Greenfields Battery Energy Storage System

Addendum to the Environmental Statement

June 2025

Figure A7.7 Specific Sound Level Map – Daytime and Night-time

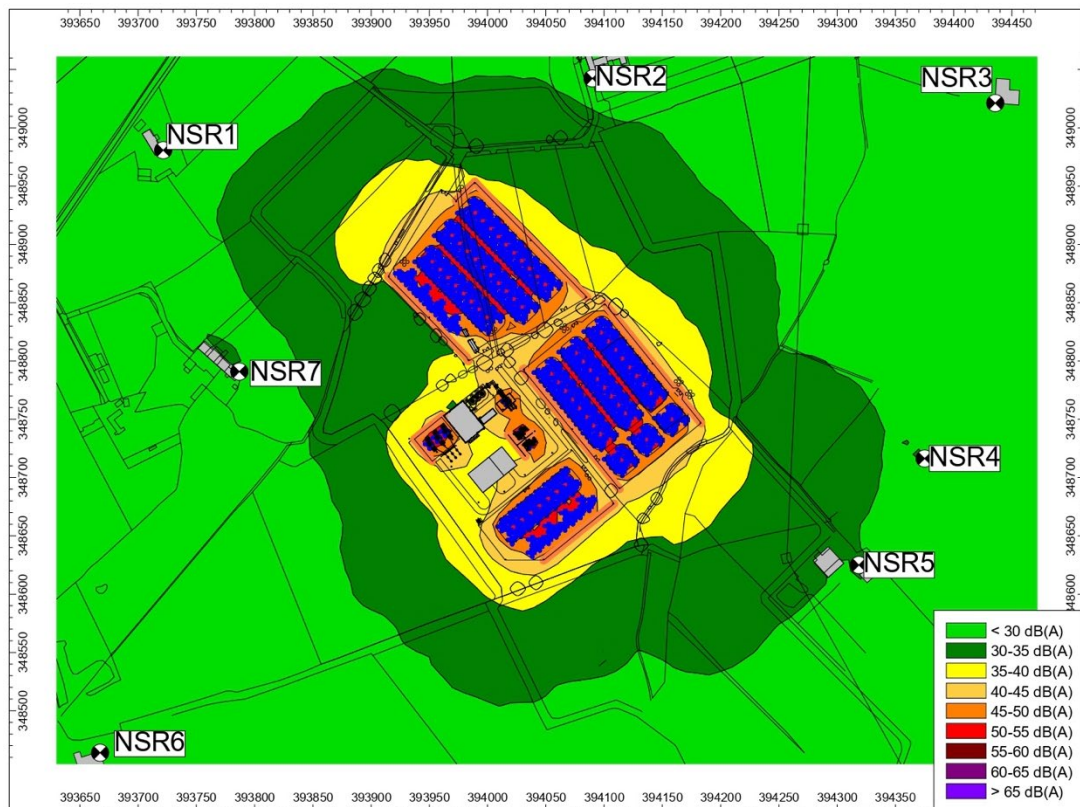
To replace paragraph 7.7.4 of Chapter 7 of the 2024 ES:

- 0.4.36 The sound map showing the daytime and night-time specific sound level emissions from the Proposed Development with acoustic fencing is now shown in Figure A7.7.
